Part Change Notice: CE2 Series Packaging Change

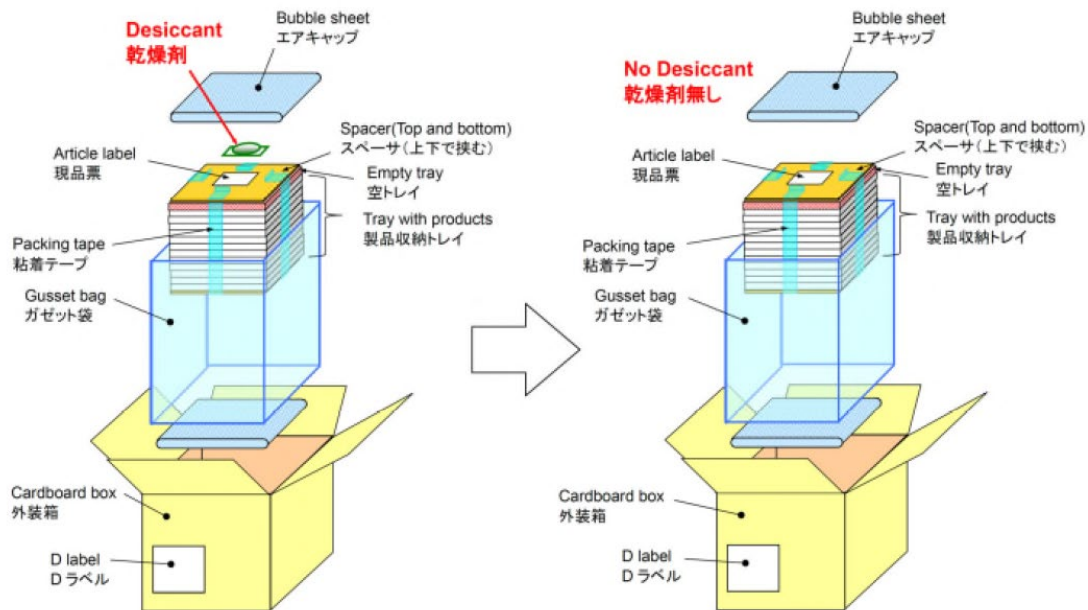
JAE will modify the inner packaging for the CE2 Series connectors by removing the desiccant that was previously included. Below is a list of part numbers that are affected. Temperature and humidity testing has been conducted to ensure there is no degradation of the products due to the packaging changes. The dimensions of the packaging and connectors are unchanged.

The desiccant that was previously included in the inner packaging has been removed.
